## SAFETY NOTICE Affects: Coal Mining Hazardous Area ONLY

### Item for Review Austdac Pullkey – Aluminium Crimp

PHOTO 1: PULLKEY

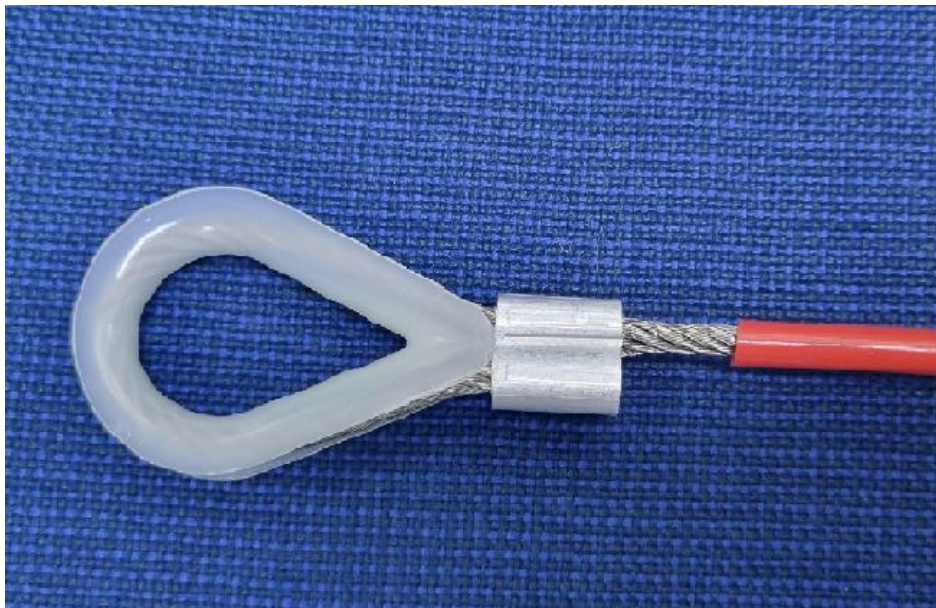
Photo 1 below shows the location of the relevant crimp. In the event that an aluminium crimp was used on the Pullkey, the crimp will be in the form of a figure 8, as is shown in Photo 2. The plated copper or stainless-steel crimp will appear as a hexagonally shaped crimp, as shown in Photo 3.

PHOTO 2: ALUMINIUM CRIMP SHOWN. NOTE THE FIGURE OF 8 SHAPE.

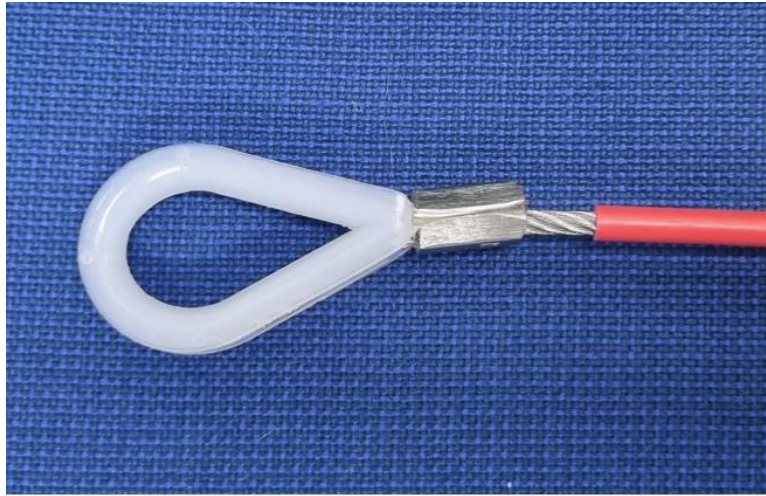
As previously notified Austdac is voluntarily notifying customers that, due to an error by our production partner, certain Austdac branded Pullkey products manufactured between January 2020 and March 2023 may contain an aluminium crimp that is not in accordance with the published product specifications. While Austdac is not aware of any product failures or injuries, we note that per the product specifications, Pullkeys should be fitted with a plated copper or stainless-steel crimp.
